HISTORIC PRESERVATION BOARD

HISTORIC PRESERVATION BOARD MEETING

The Historic Preservation Board will hold a remote meeting on Wednesday, April 20, 2022, 5:00 PM. This meeting will take place remotely using Zoom pursuant to the Remote Meeting Policy adopted by the Historic Preservation Board and as authorized under 1 M.R.S. 403-B because of the existence of an emergency or urgent issue that requires the committee to meet by remote methods.

**PROPOSED
PLANS**

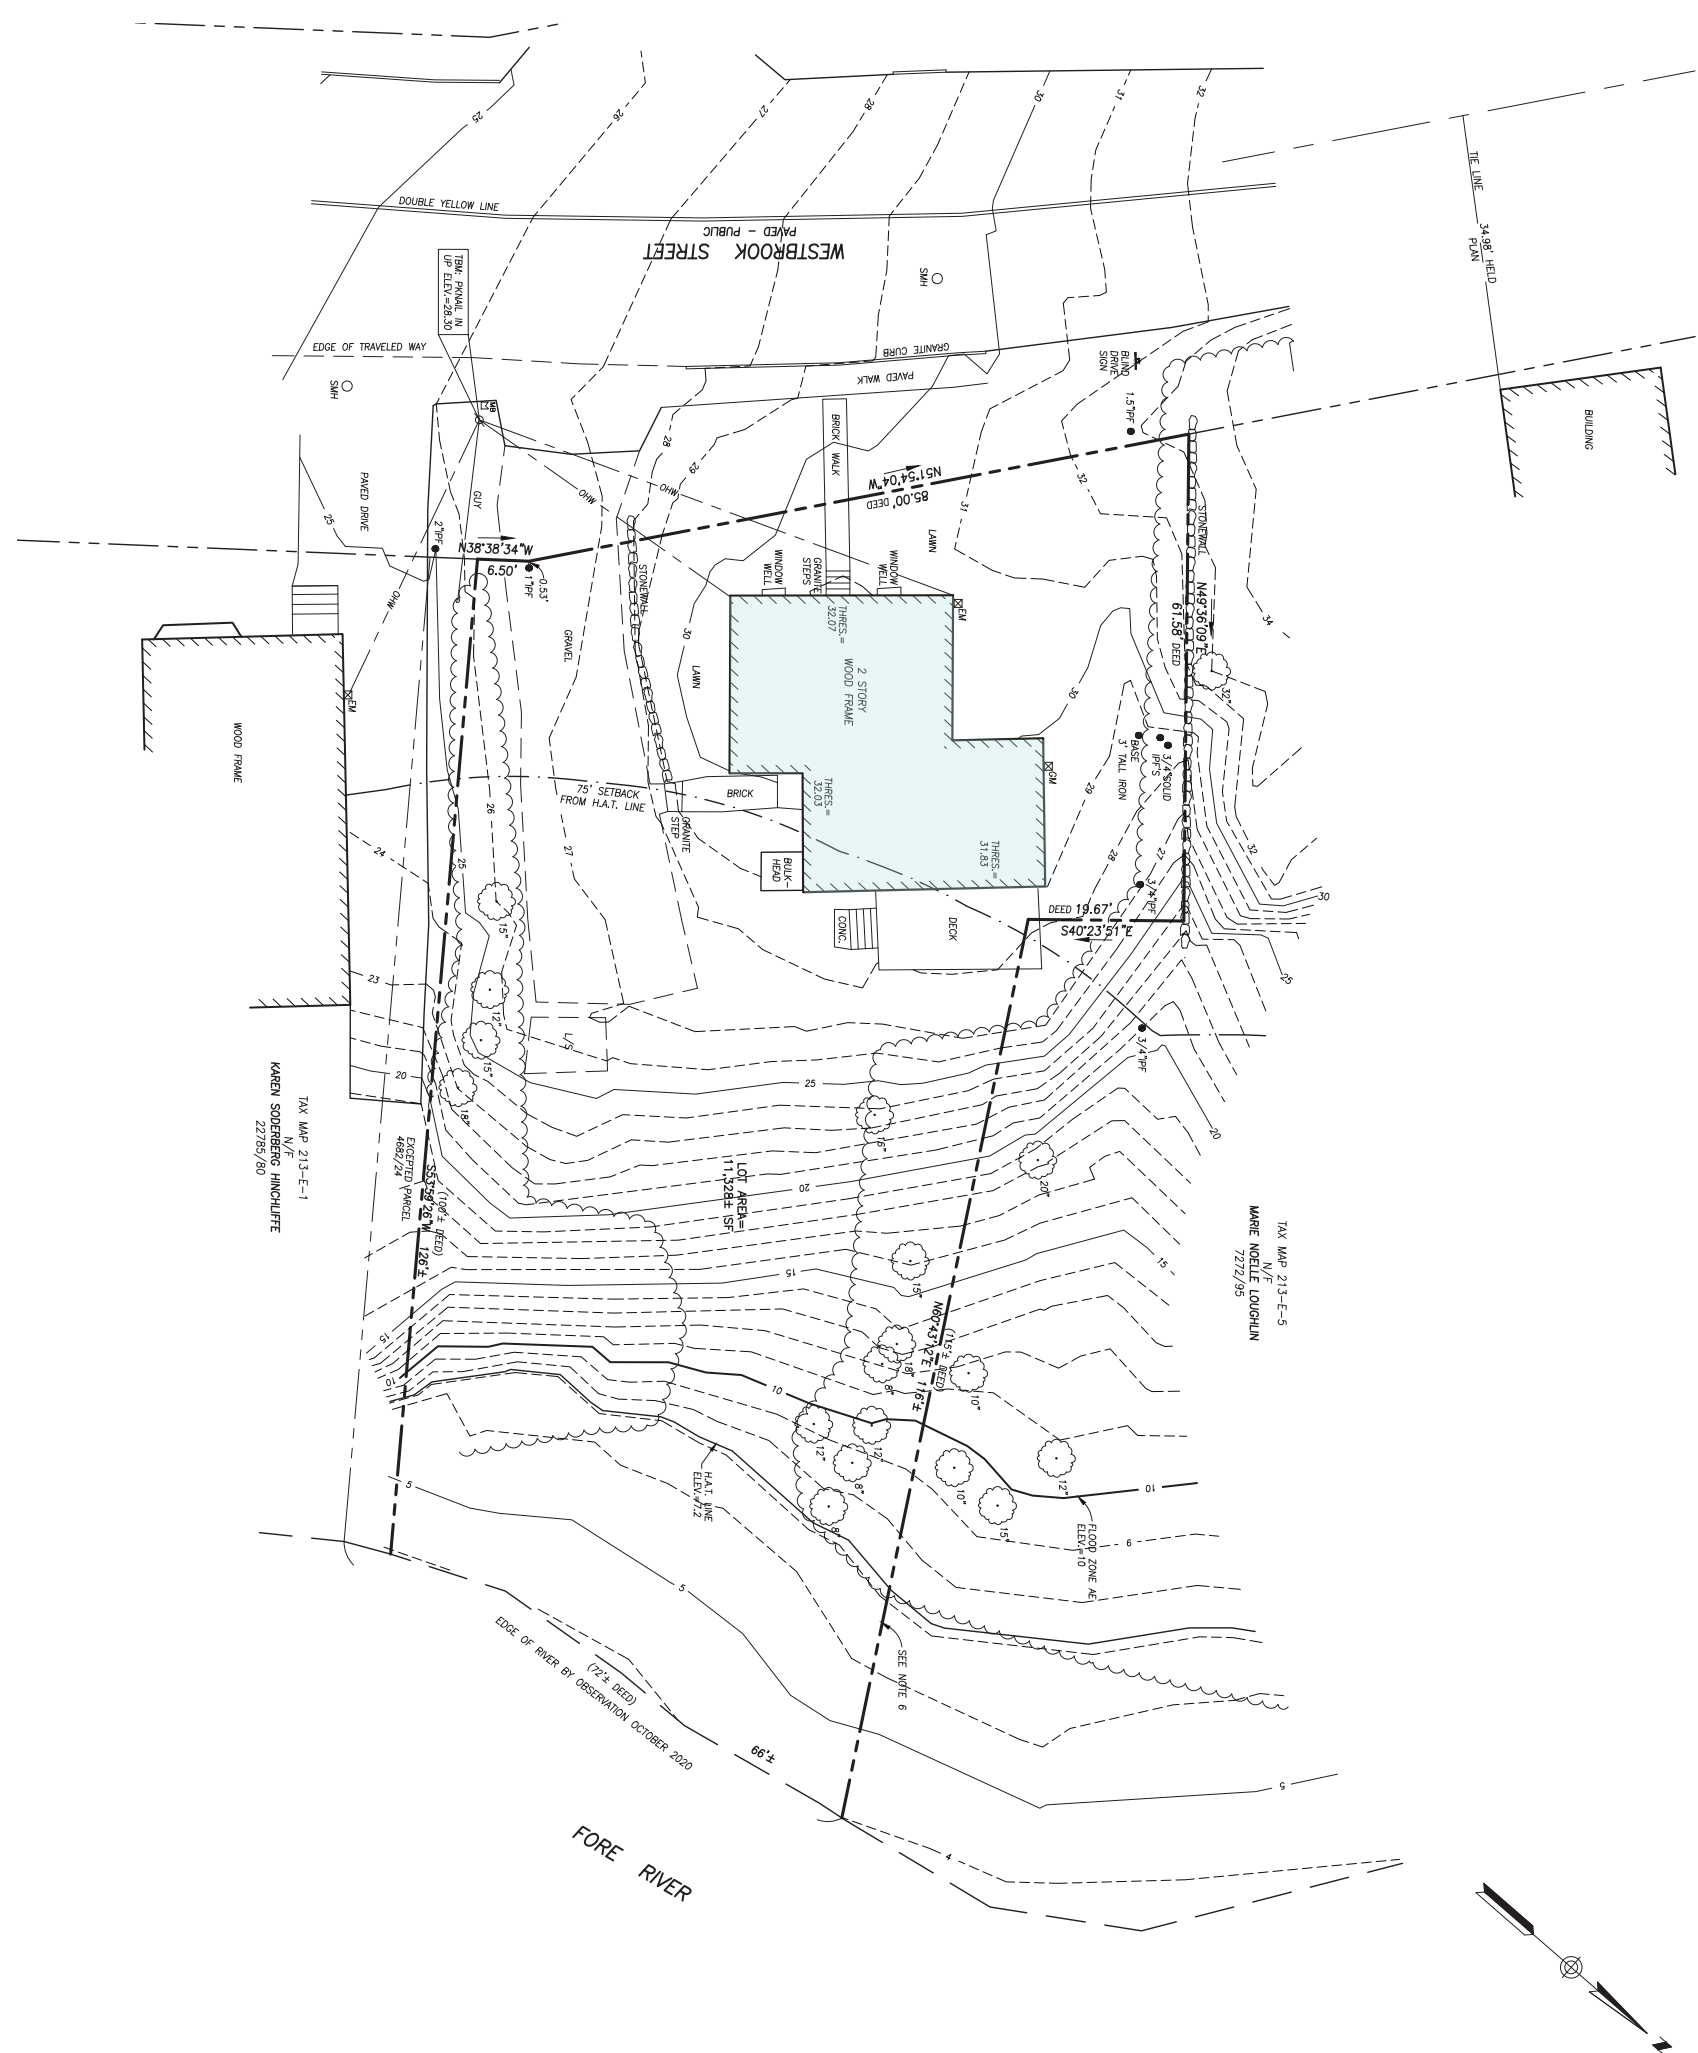
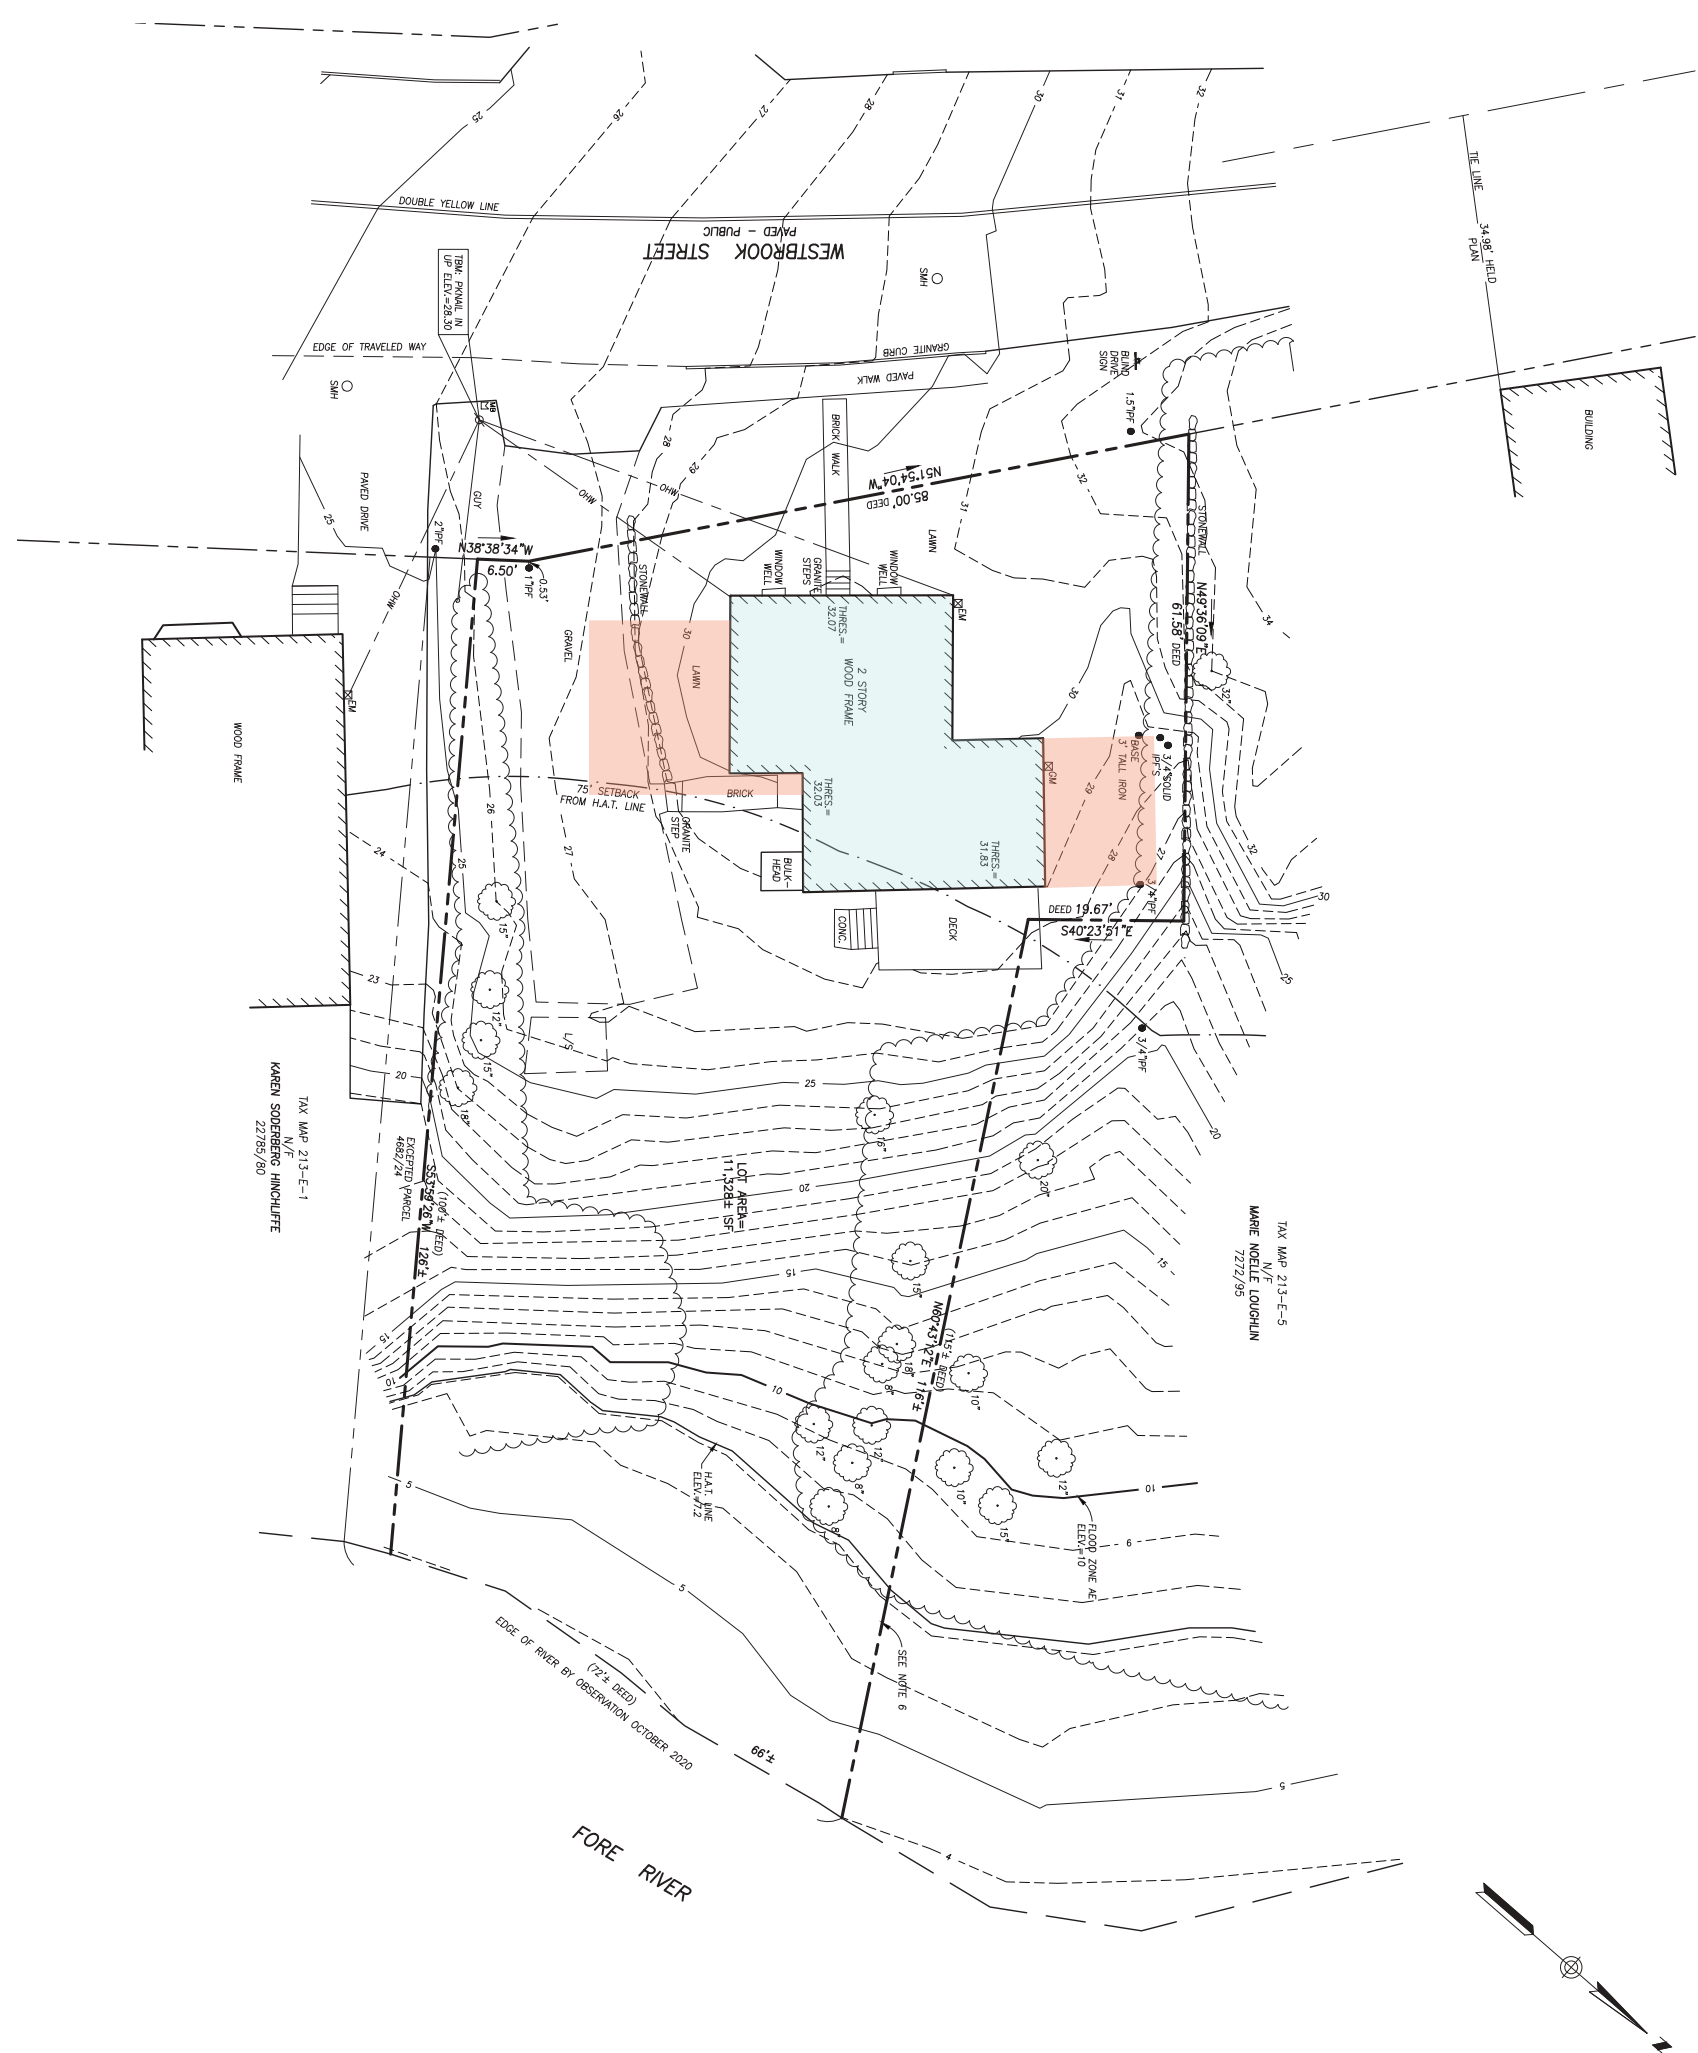
Site Alterations: Staff suggests that Board members ask for clarification about the scope and nature of site alterations, as the enclosed site plan and renderings are not consistent. For example, is a stone wall and second walkway from the driveway to the front door proposed? Will there be a transition in paving materials for the area on the southeast side of the garage, as suggested?

The roof over the connecting entryway between the new garage and the existing house has been held back from the front edge of the garage/MBR addition by 12", and the front door has been set back 42" from the roof edge to more clearly articulate the space between the old and the new. The revised configuration reduces the visual impact of the garage/MBR addition on the original house. Allowing the garage/MBR addition to read as more separate from the historic house, more legible as an addition and not part of the original structure. The breezeway has a full glass door and sidelight on the front, creating a clear separation between the historic house and the garage/MBR addition. The garage door has been moved to the inside of the entryway, to simplify the exterior form of the garage at this important intersection.
